ADAMSTOWN BOULEVARD PHASE 1

GRANT REF: SDZ22A/0007

INTRODUCTION - PLANNING CONDITIONS

This document is in response to Condition 7 and prepared by McCauley Daye O'Connell Architects.

4.1 HOUSE TYPE H4AD AMENDMENTS TO PLANNING APPLICATION

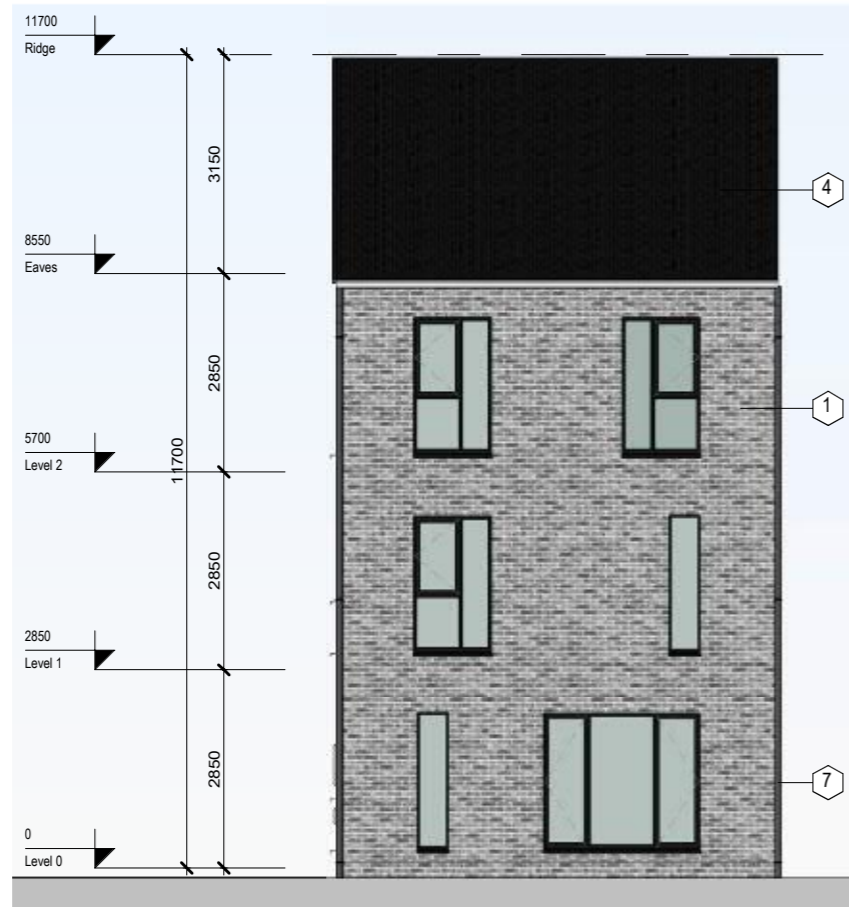
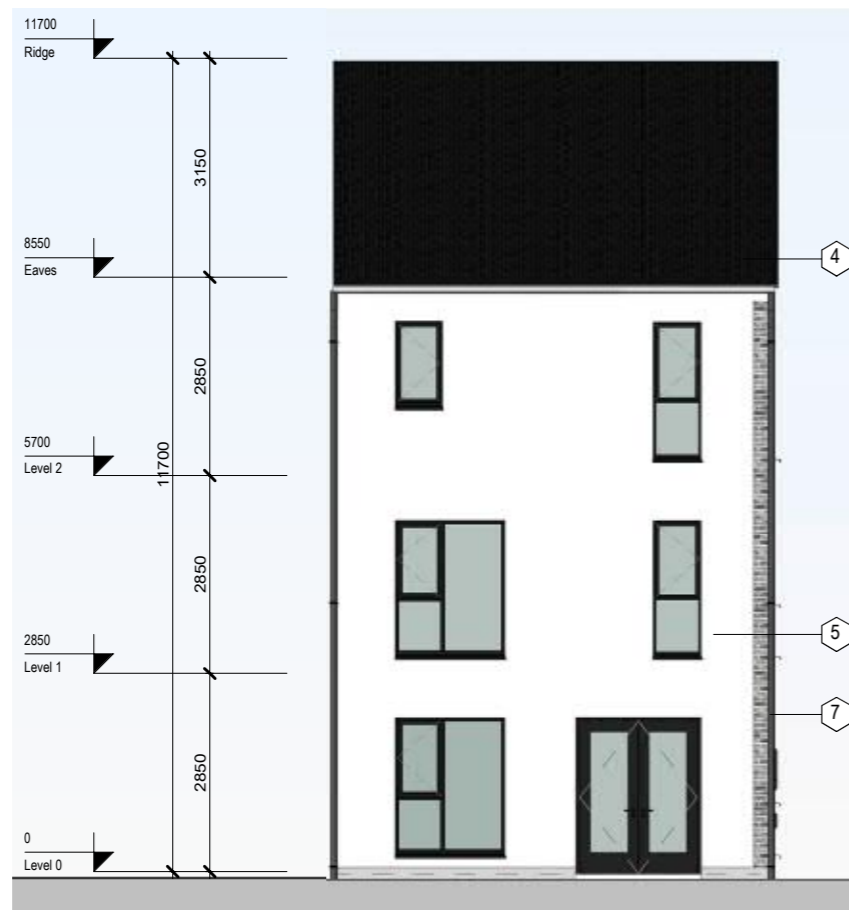
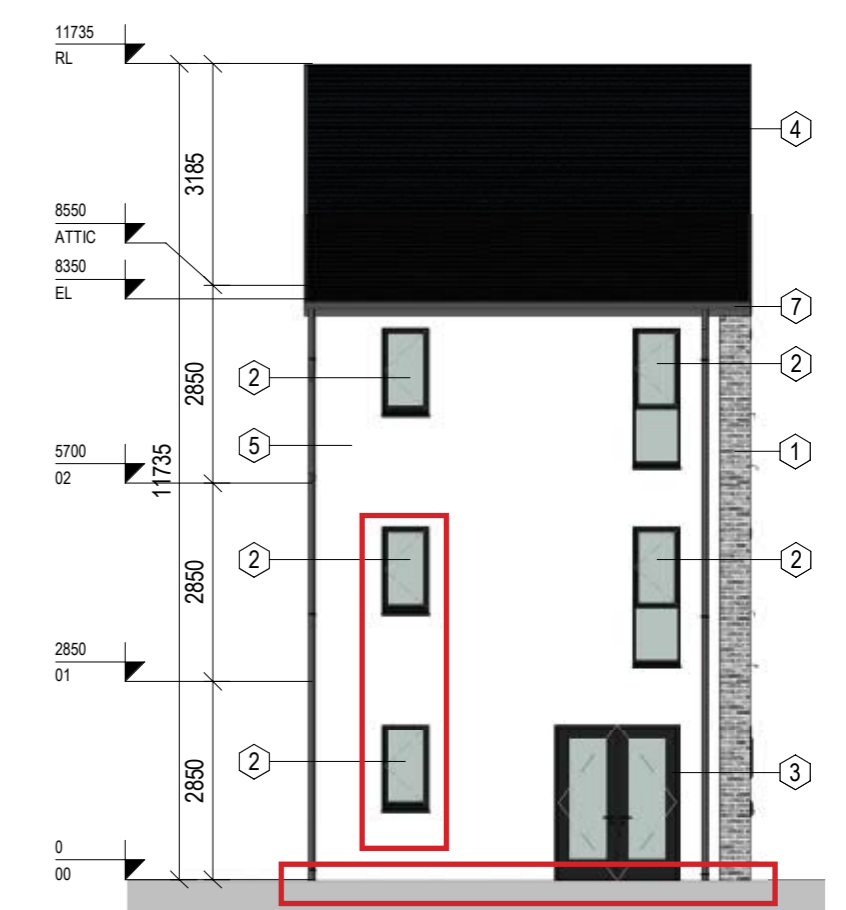
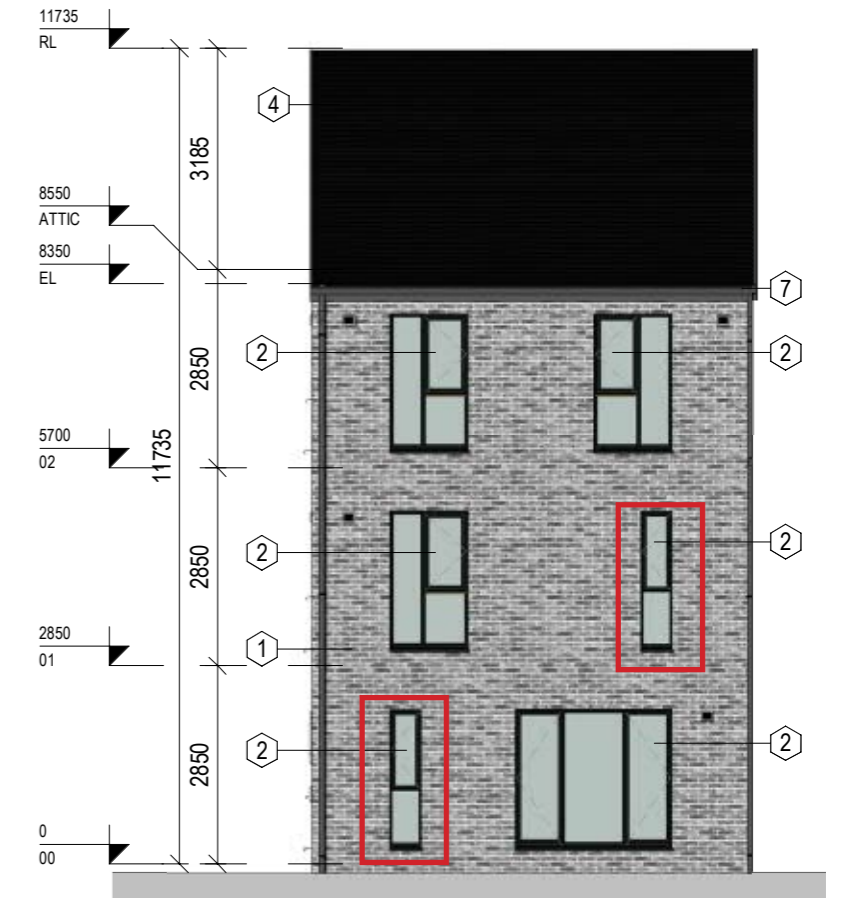
- Plinth to rear removed
- Window type amended
- Higher ridge level

4.1 HOUSE TYPE H4AD AMENDMENTS TO PLANNING APPLICATION

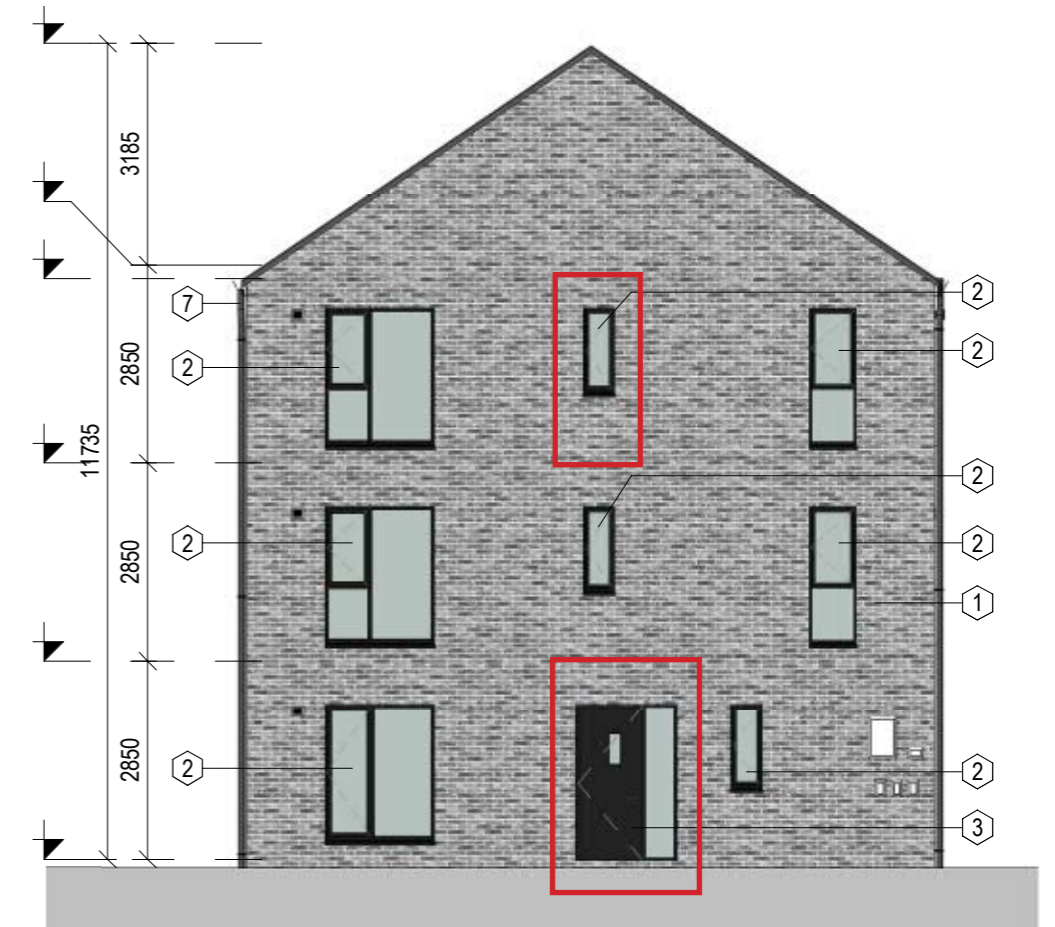
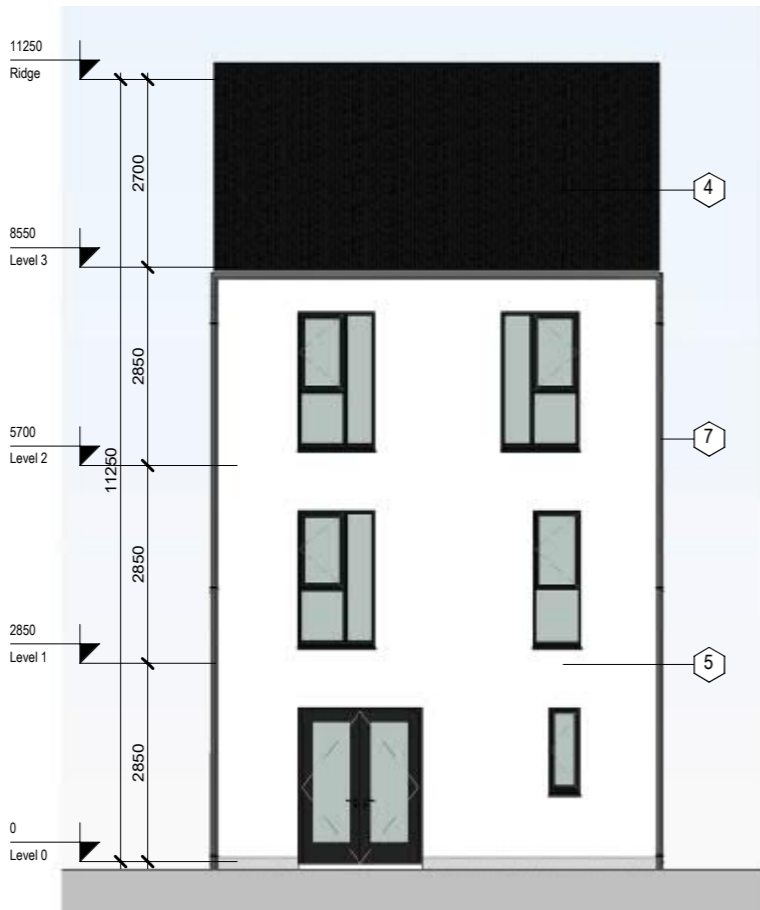
- Entrance door type amended
- Window introduced

4.2 HOUSE TYPE H4BB AMENDMENTS TO PLANNING APPLICATION

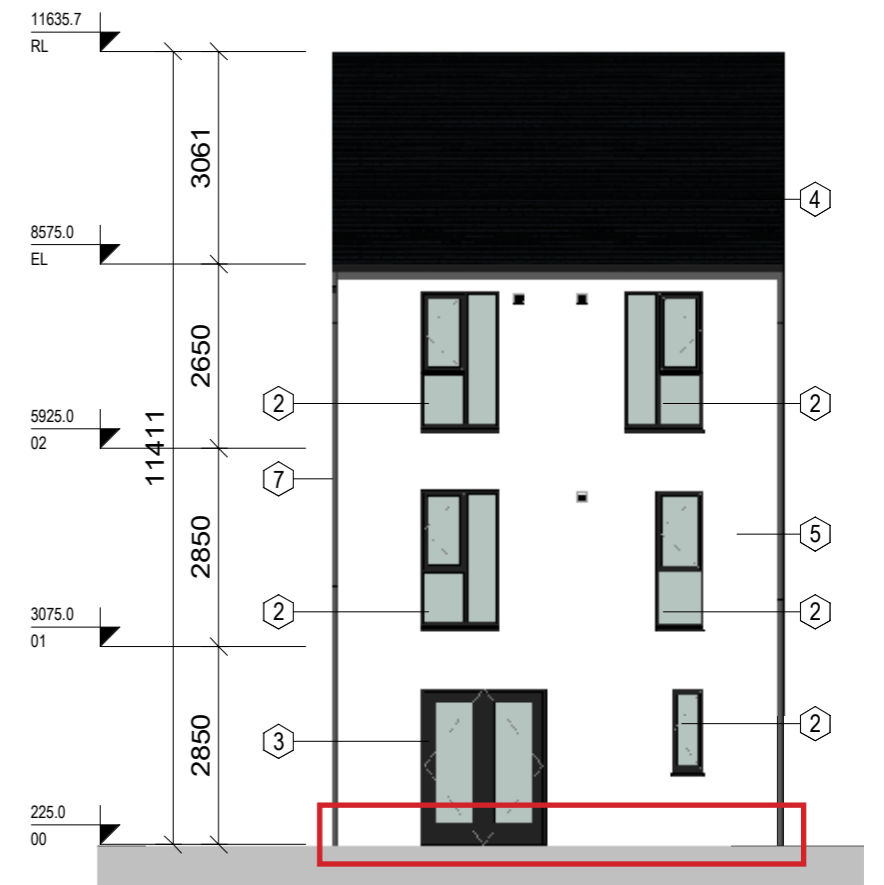
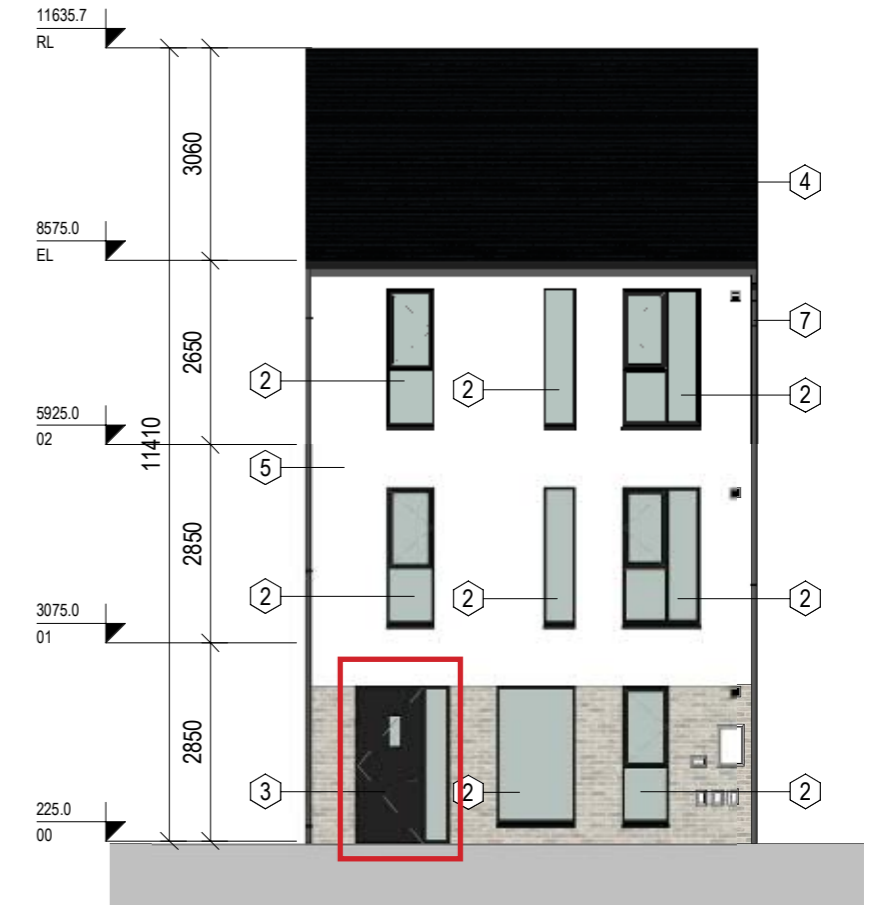
- Plinth to rear removed
- Front door side panel enlarged
- Higher ridge level

4.4 HOUSE TYPE H4BC AMENDMENTS TO PLANNING APPLICATION

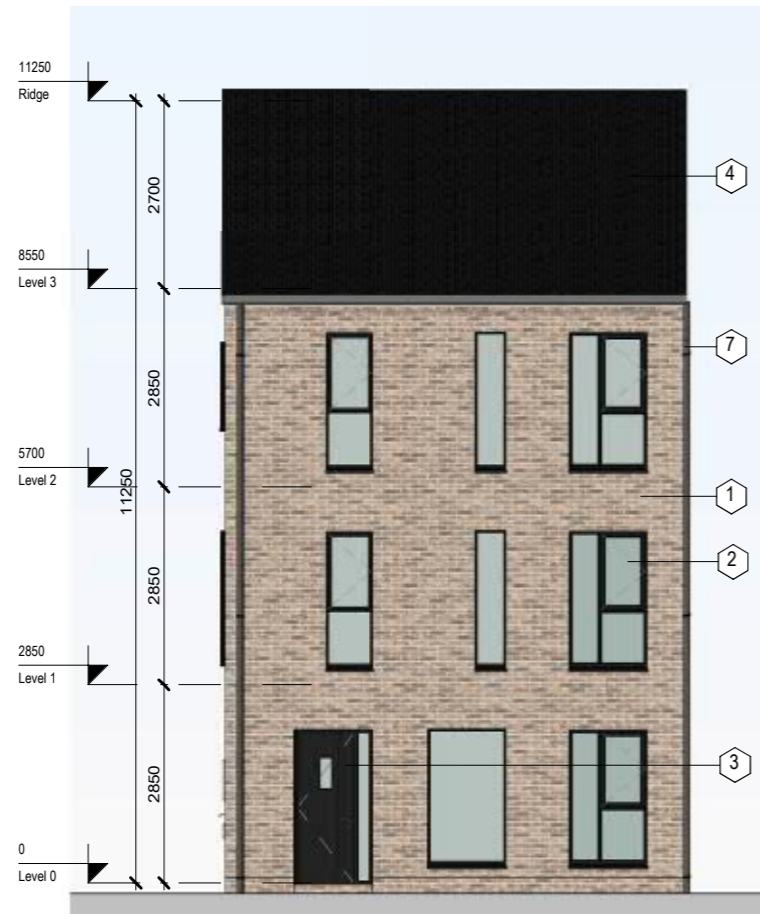
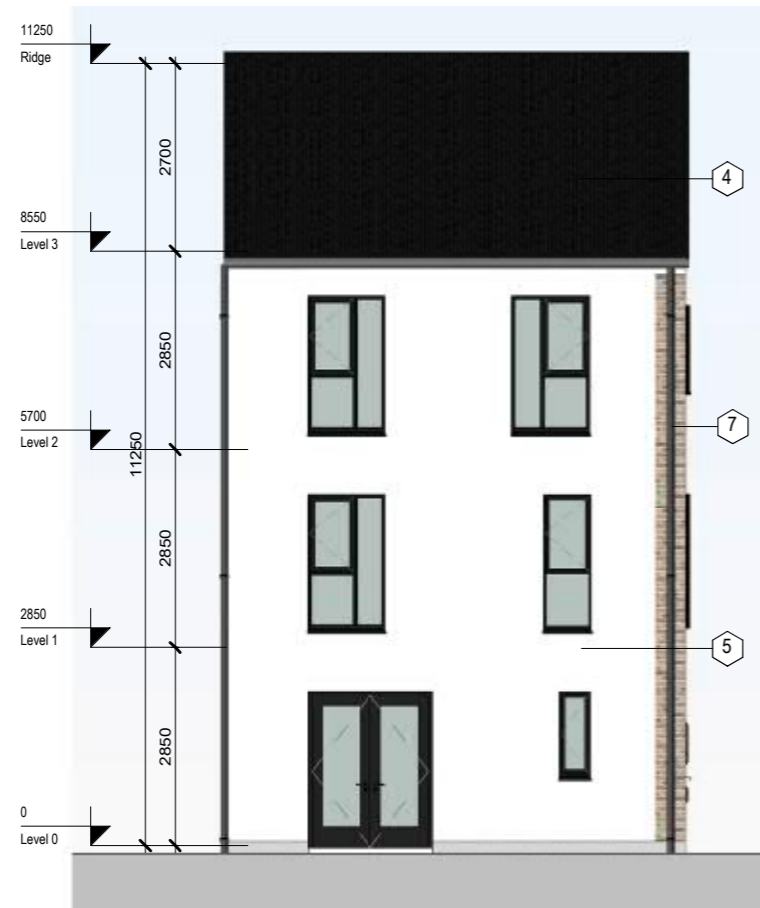
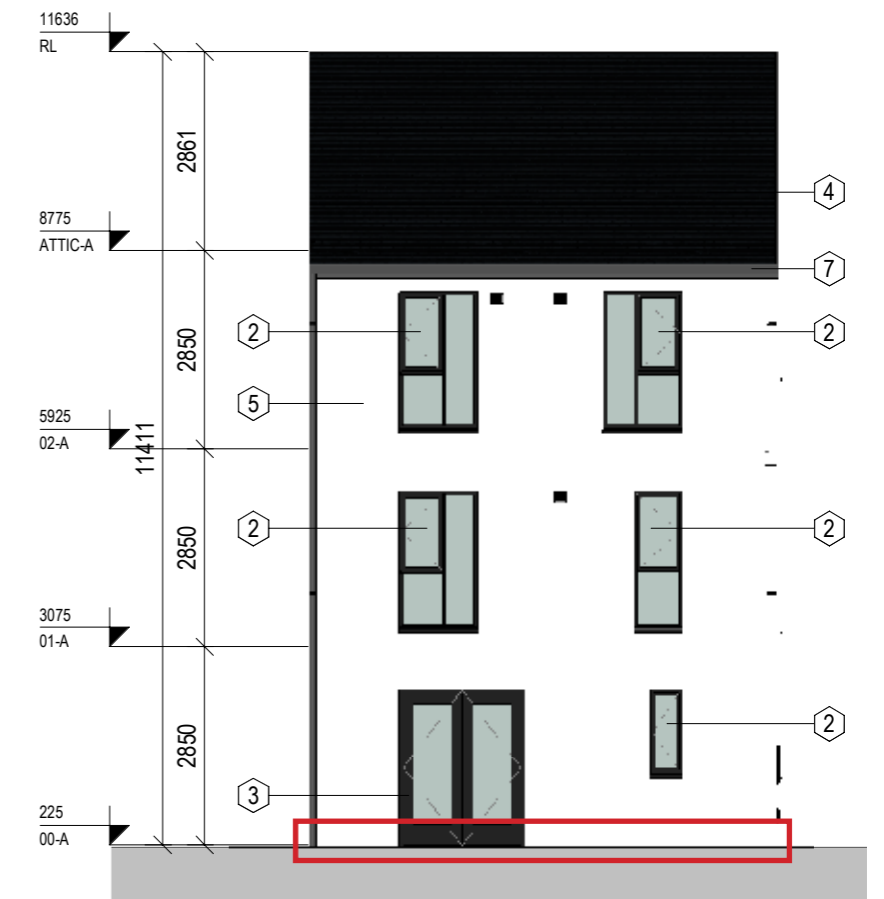
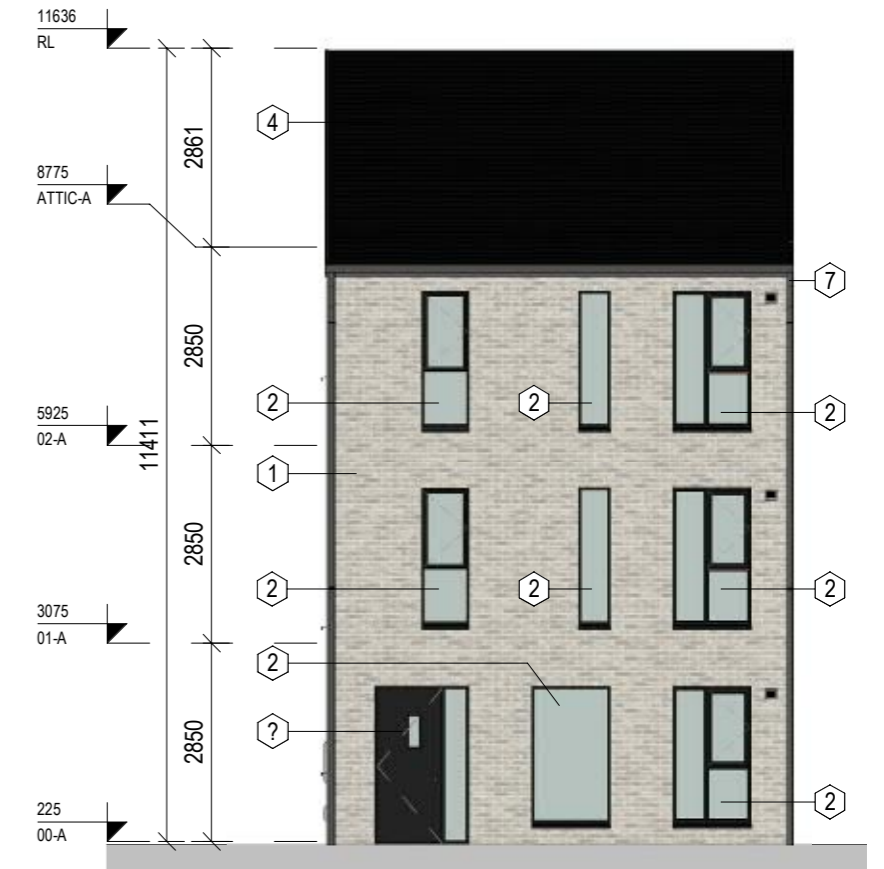
- Plinth to rear removed
- Higher ridge level

4.4 HOUSE TYPE H4BC AMENDMENTS TO PLANNING APPLICATION

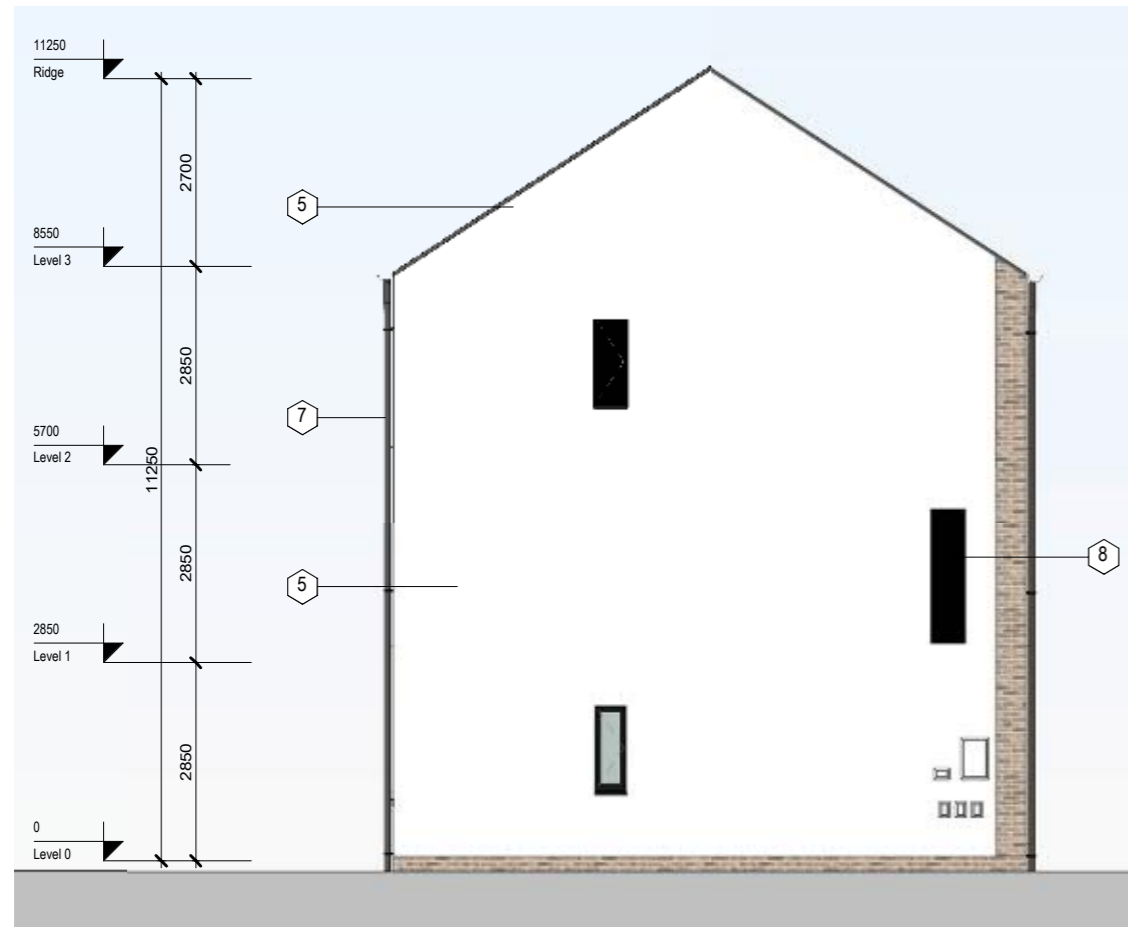
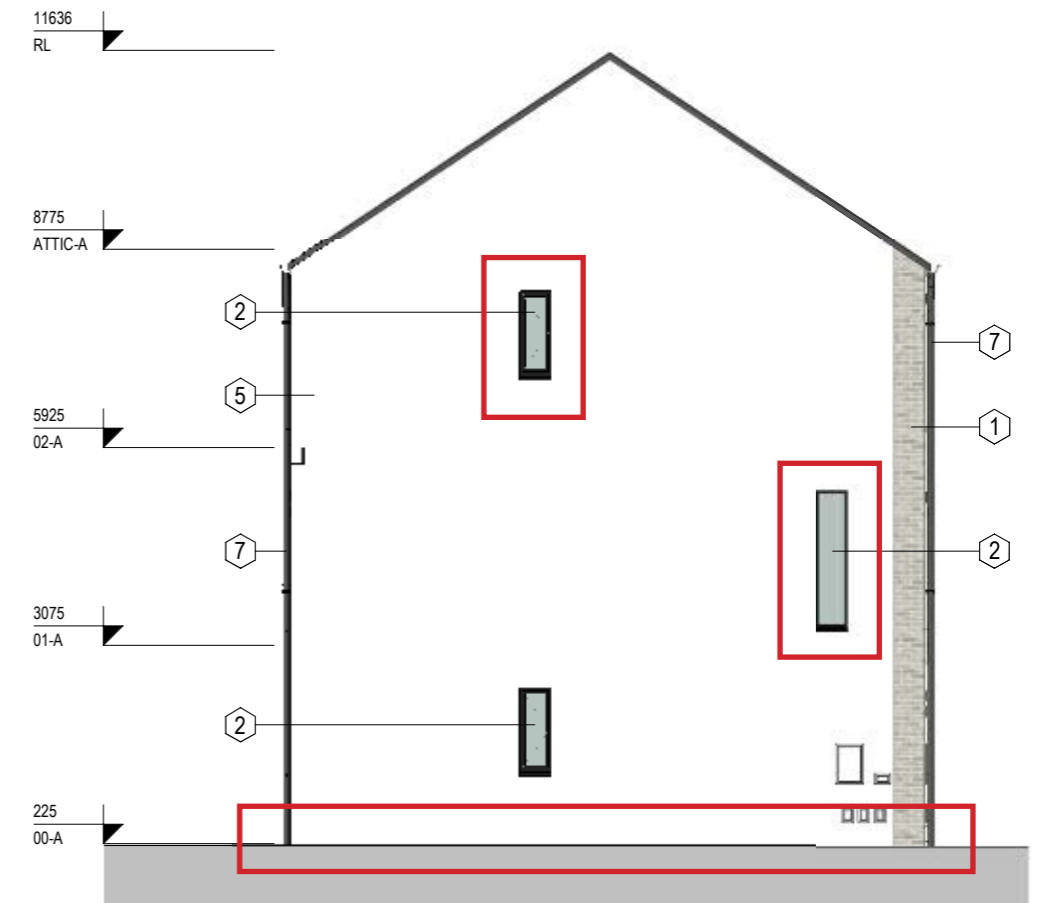
- Brick plinth removed
- External louvers replaced with opaque glass
